Re: Initial Submission Review: The Aurora Highlands Master Plan Amdt No 3 - Master Plan Amendment
Application Number: DA-2062-52
Case Number: 2017-7002-04

Initial Submission Review

Tab 10 – Urban Design Standards

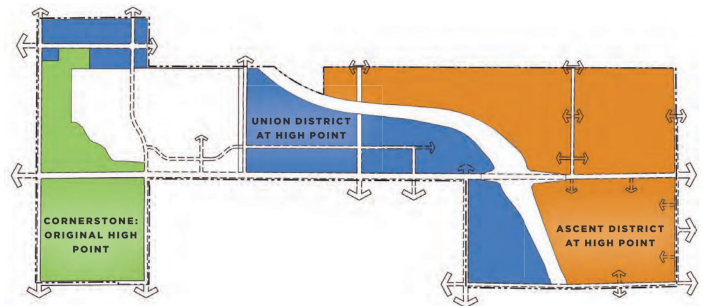
- 3W. Consider establishing sub-areas in the Urban District that will guide the character and design standards. These sub-areas could/should be referenced in all the design standard tabs. See the example to the right.
